ADDENDUM NO. 2

GAGE DRAIN PUMP STATION AND OPEN CHANNEL SAGINAW COUNTY, MICHIGAN

RE: CHANGES TO BIDDING DOCUMENTS

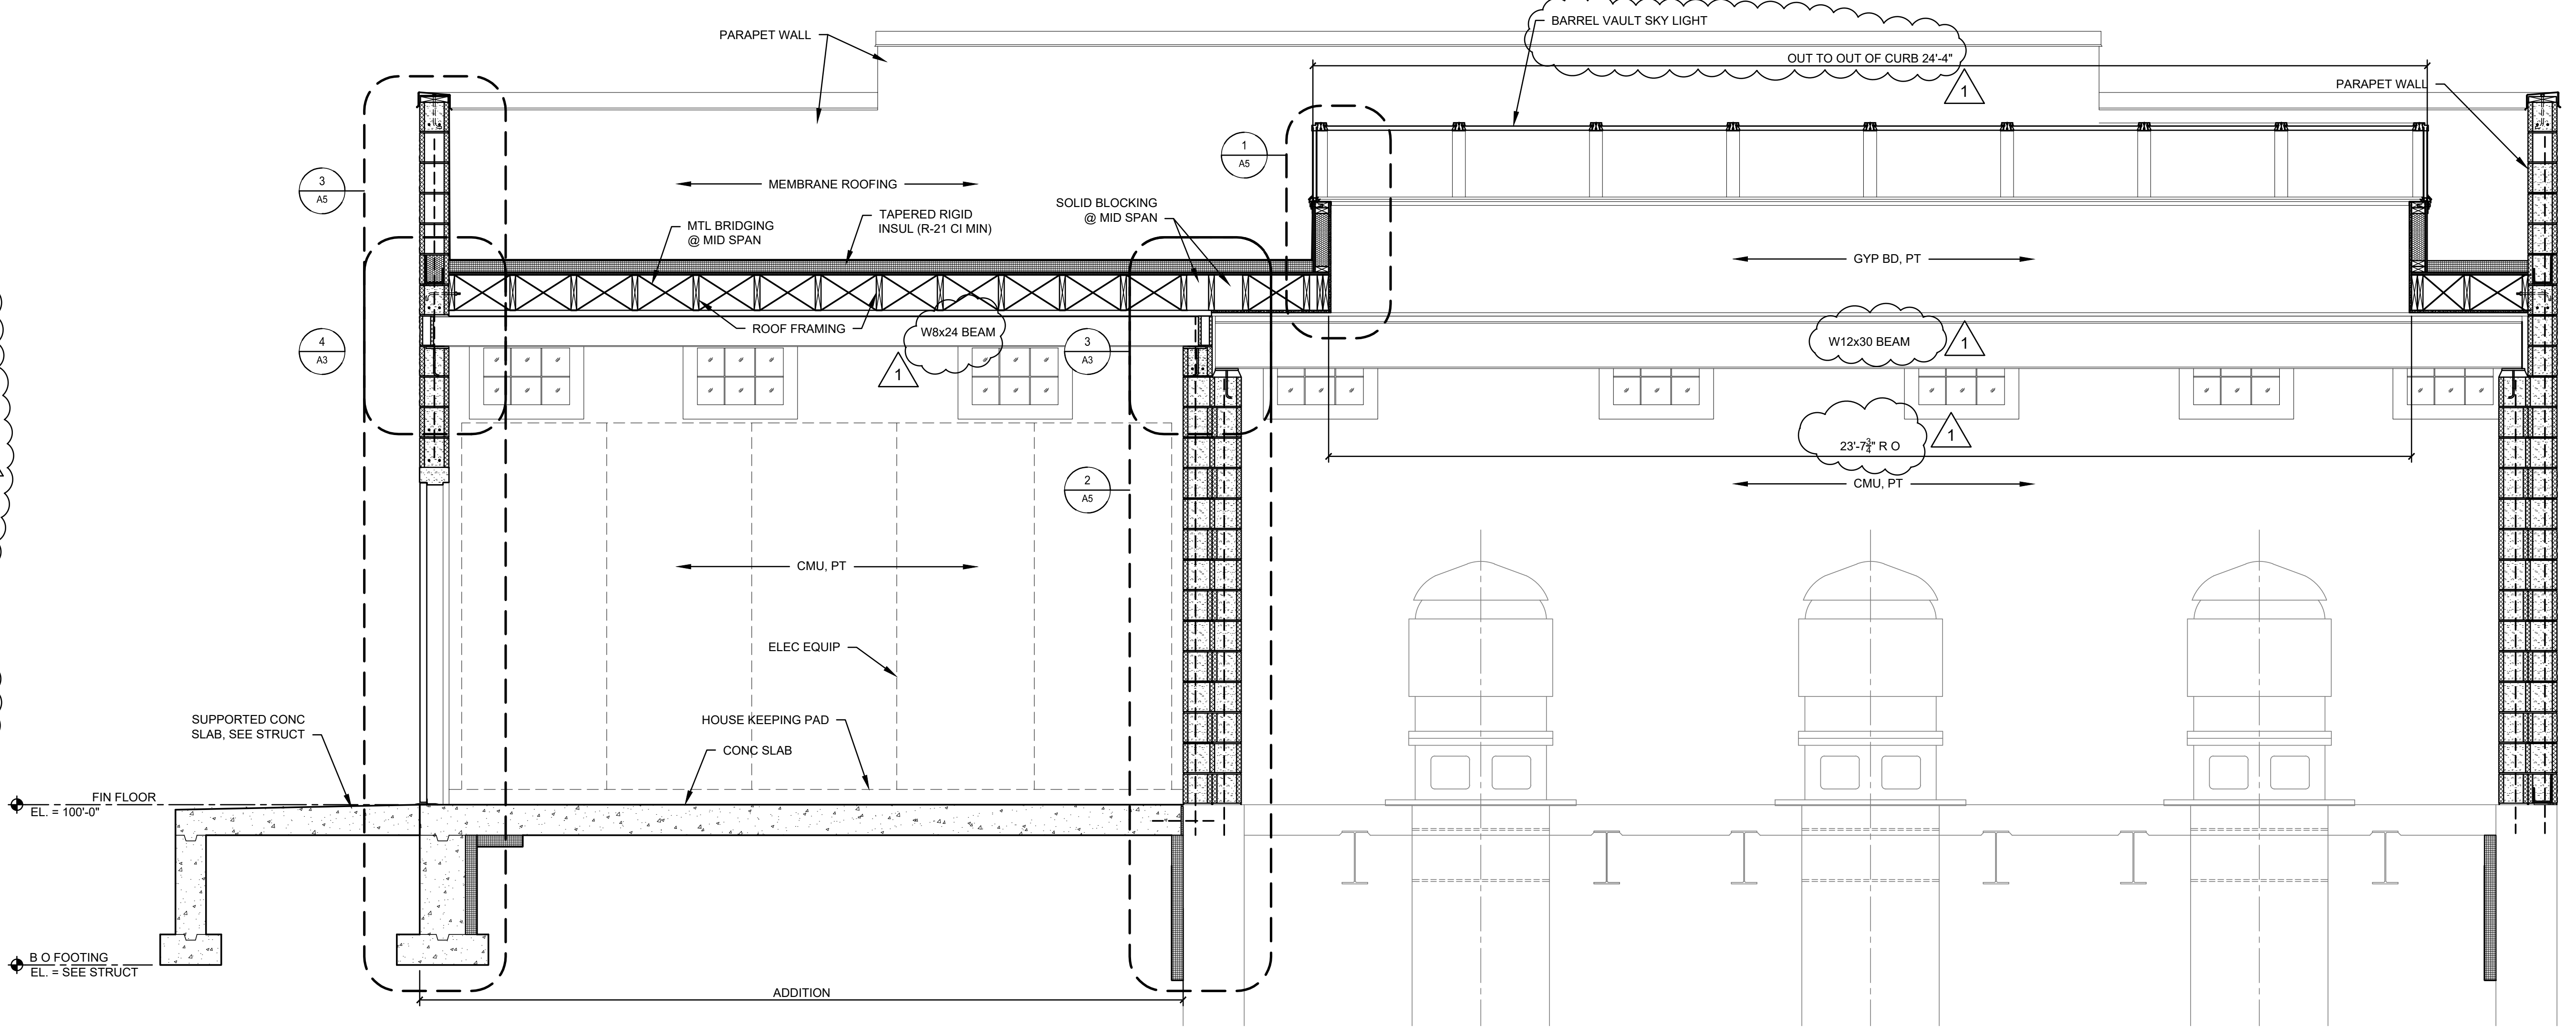
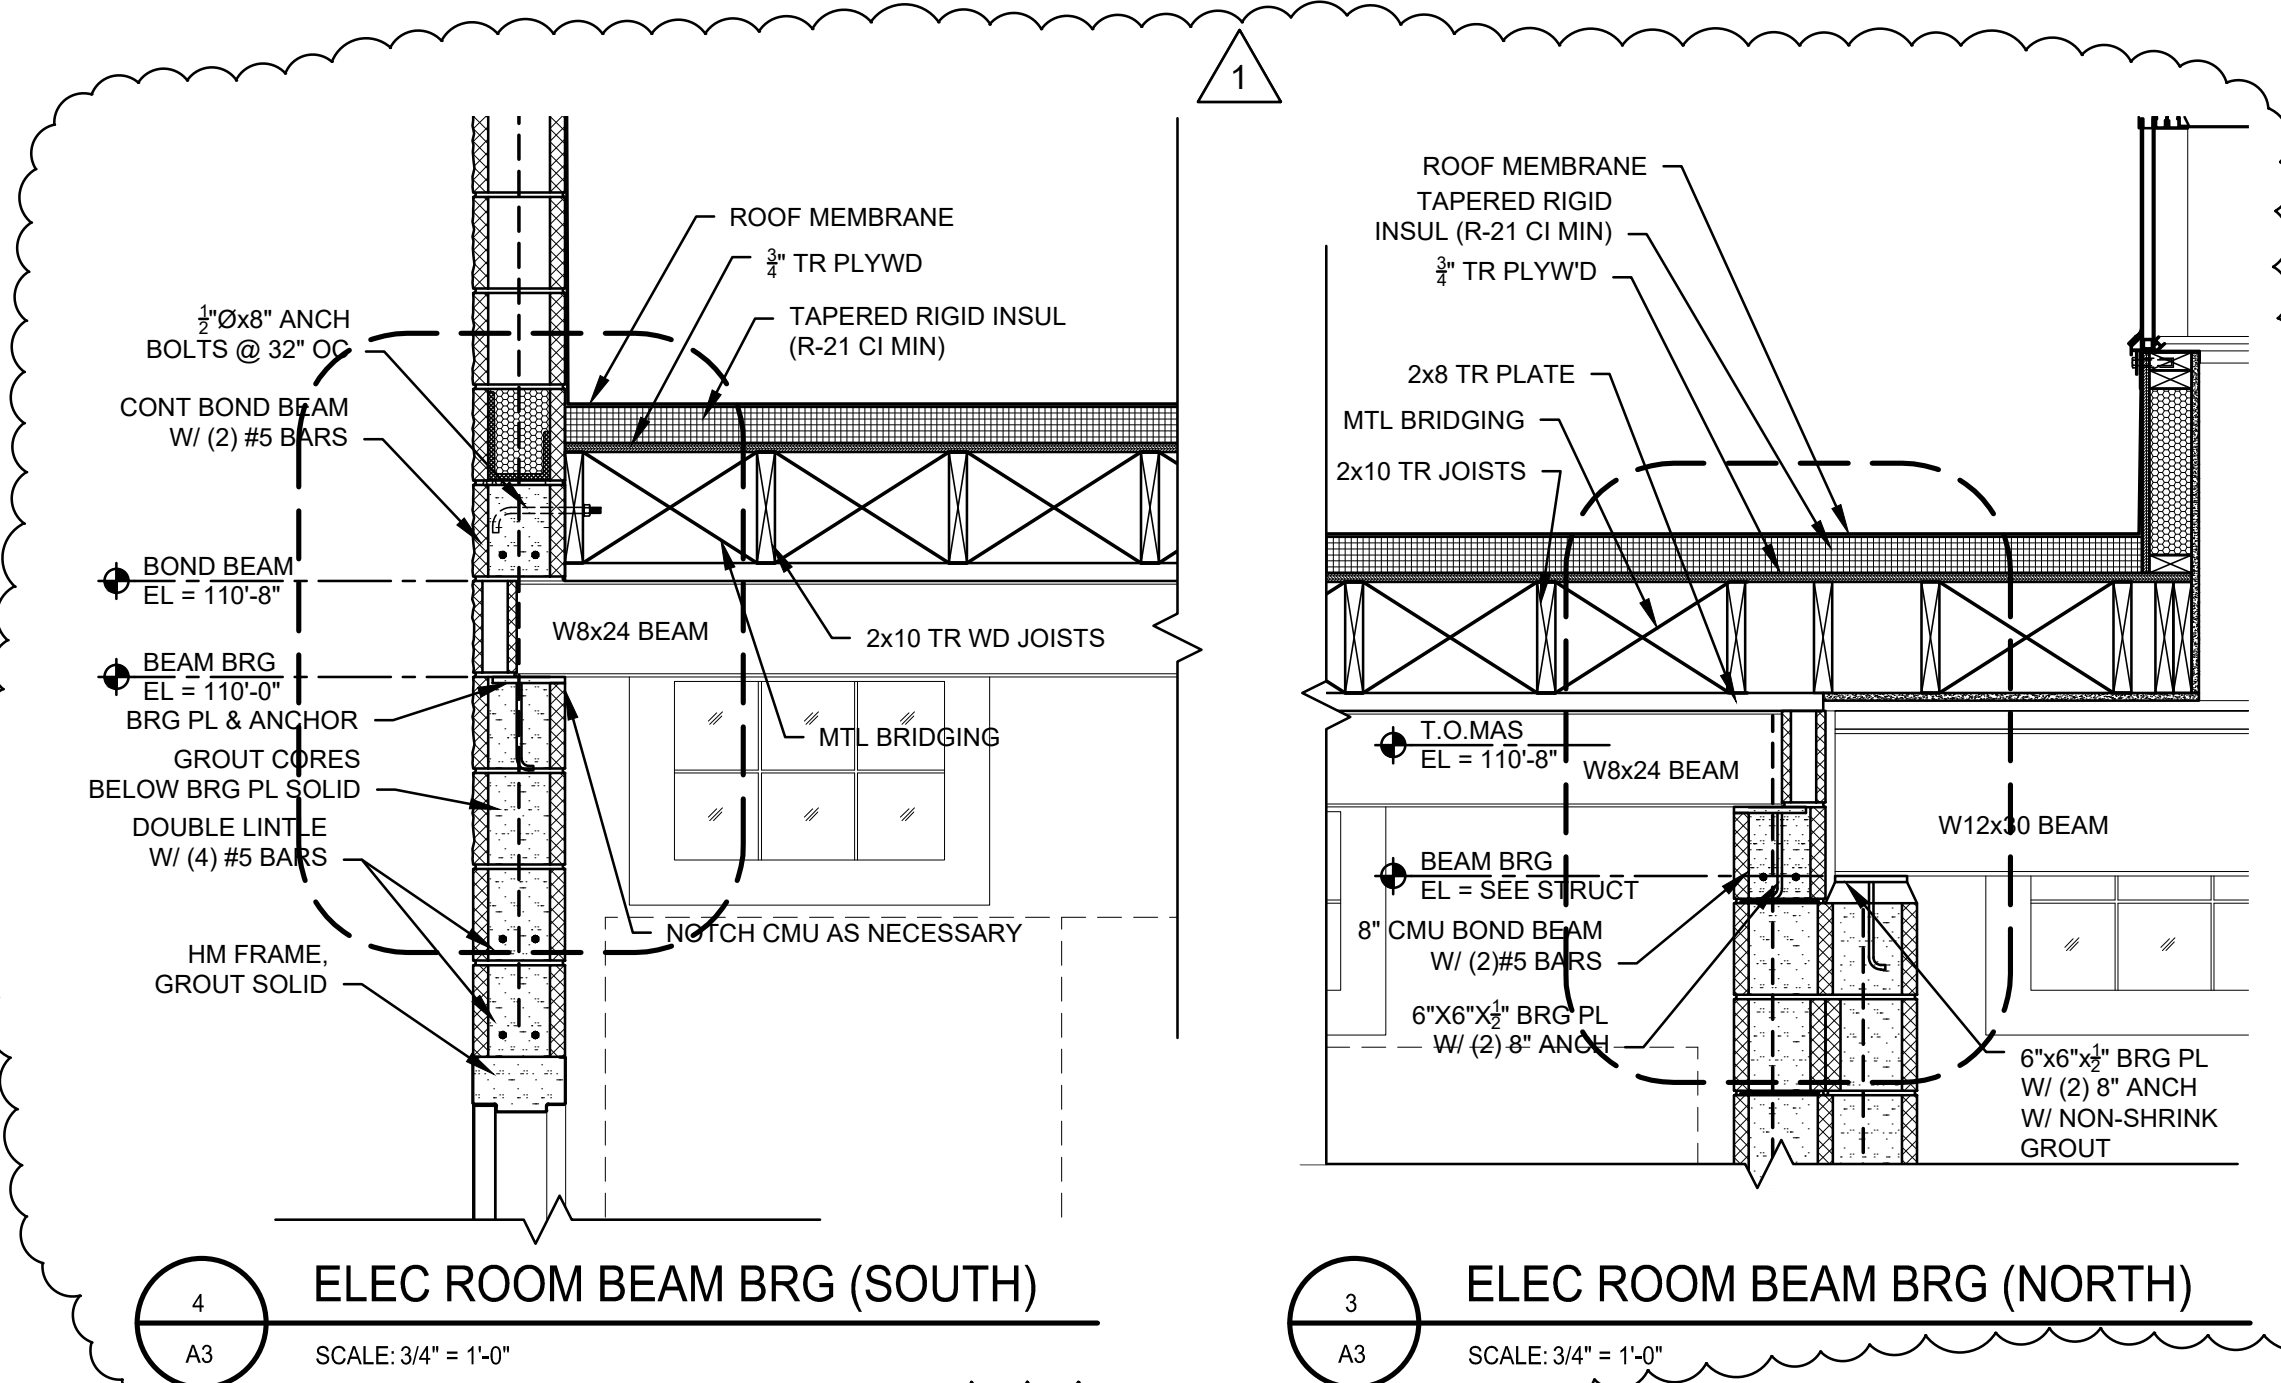
1. Addendum No. 2 has been posted to the Saginaw County Public Works Commissioner's website on Wednesday, February 17th, 2021.
2. Division I - Sheet A3 (Sheet 33 of 41 in the plan set) has been revised and reissued as part of this addendum to add a support beam for the roof in the electrical/control room. The revised Sheet A3 also has added notes and details in response to bidder questions regarding the glass block windows and the barrel vault skylight.

- The contractor will be responsible for providing the warning light and audio alarm for the trash rack.
 - Additional information for the glass block windows is included in the revised A3 sheet included with this addendum.

- Additional information for the barrel vault skylight is included in the revised A3 sheet included with this addendum.
4. Division II Clarifications in response to bidder questions:

NOTE:
 W8x24 BEAM IN ELECTRICAL ROOM SHALL BE IN-LINE WITH EASTERN MOST BEAM IN PUMP ROOM

BARREL VAULT SKYLIGHT SYSTEM NOTES:

SUPPLY AND INSTALL COMPLETE AN ACRYLIC DOMED SKYLIGHT SYSTEM AS SHOWN ON THE DRAWINGS.

- SKYLIGHT SHALL BE CONSTRUCTED AND INSTALLED TO ENSURE A WEATHER TIGHT INSTALLATION. SKYLIGHT SHALL HAVE SPECIAL LIFTING LUGS FOR RIGGING AND REMOVAL BY CRANE STRAPS.

- SKYLIGHT FRAME, GLAZING TRACK, MULLIONS AND RAFTERS SHALL BE CONSTRUCTED OF ALUMINUM. FRAME SHALL BE CURB MOUNTED. FRAME SHALL HAVE A POLYURETHANE THERMAL BREAK AND AN INTEGRAL GUTTER AND WEEP SYSTEM FOR DRAINAGE TO THE EXTERIOR. FRAME CONSTRUCTION SHALL BE WELDED.

- ACRYLIC DOMES SHALL BE BRONZE OVER CLEAR. DOMES SHALL BE SECURED TO FRAME WITH A FULLY WELDED RETAINER CAP.
- ALL EXPOSED ALUMINUM SHALL BE MILL FINISH. ALL GLAZING SHALL BE SEPARATED FROM FRAME BY A CONTINUOUS EXTRUDED BLACK SANTOPRENE GASKET. ALL HARDWARE SHALL BE STAINLESS STEEL.

- SKYLIGHT SHALL BE FACTORY ASSEMBLED AND FACTORY GLAZED. SKYLIGHT SHALL BE INSTALLED IN STRICT ACCORDANCE WITH MANUFACTURERS INSTRUCTIONS.
- BARREL VAULT SKYLIGHT SHALL BE FASTENED TO CURB WITH BOLTS AND T-NUTS OR THREADED INSERTS EMBEDDED IN THE CONSTRUCTED CURB. FASTENERS SHALL MEET MANUFACTURERS RECOMMENDATIONS FOR SIZE AND SPACING WITH A MAXIMUM SPACING OF 12" O.C.

GLASS BLOCK NOTES:

SUPPLY AND INSTALL 8"x8"x4" GLASS BLOCKS IN INDIVIDUAL UNITS AS SHOWN ON THE DRAWINGS.

PRODUCT:
 1. THICK FACED GLASS BLOCK UNITS, NOMINALLY 8"x8"x4" THICK SHALL BE PARTIALLY EVACUATED HOLLOW UNITS MADE OF CLEAR, COLORLESS GLASS WITH A POLYVINYL BUTYRAL EDGE COATING.

- PATTERN TYPE: EQUAL TO SEVES WAVE
- MORTAR: LIMIT CEMENTITIOUS MATERIALS IN MORTAR TO PORTLAND CEMENT AND LIME. TYPE S IN ACCORDANCE WITH ASTM C270. MORTAR SHALL BE 1 PART PORTLAND CEMENT, 1/2 PART LIME, AND SAND EQUAL TO 2 1/2 TO 3 TIMES THE AMOUNT OF CEMENTITIOUS MATERIAL (CEMENT PLUS LIME), ALL MEASURED BY VOLUME. (FOR EXTERIOR GLASS BLOCK PANELS, AN INTEGRAL TYPE WATERPROOFER SHOULD BE ADDED TO THE MORTAR MIX.) NO ANTIFREEZE COMPOUNDS OR ACCELERATORS ALLOWED. TYPE N MORTAR IS ALSO ACCEPTABLE.

- GLASS BLOCK SHALL NOT BE DESIGNED TO SUPPORT STRUCTURAL LOADS.
- SILLS OF ALL PANELS MUST BE PAINTED WITH A HEAVY COAT OF ASPHALT EMULSION AND MUST CURE FOR TWO HOURS BEFORE FIRST MORTAR BED IS PLACED.
- MORTAR SHOULD BE MIXED AND APPLIED IN ACCORDANCE WITH THE RECOMMENDATIONS OF MANUFACTURER.
- BECAUSE GLASS BLOCK WILL NOT ABSORB WATER, MORTAR MUST BE CONSIDERABLY STIFFER THAN MORTAR FOR ORDINARY MASONRY. THE CONSISTENCY CAN BE DESCRIBED AS "MASHED POTATOES" OR "PEANUT BUTTER" AND BE CLAY-LIKE. THE JOINTS MUST BE FULL AND STRUCK SMOOTH, NOT SPONGED.
- INSTALLATION OF GLASS BLOCK SHALL BE DONE BY WHOLE UNITS. CUTTING OF GLASS BLOCK UNITS IS NOT PERMITTED.
- SUBMIT TWO (2) GLASS BLOCK UNITS OF EACH TYPE SPECIFIED, SHOWING SIZE, DESIGN AND PATTERN OF FACES.
- VERIFY ALL INSTALLATION INSTRUCTIONS WITH PRODUCT MANUFACTURERS INSTRUCTIONS.
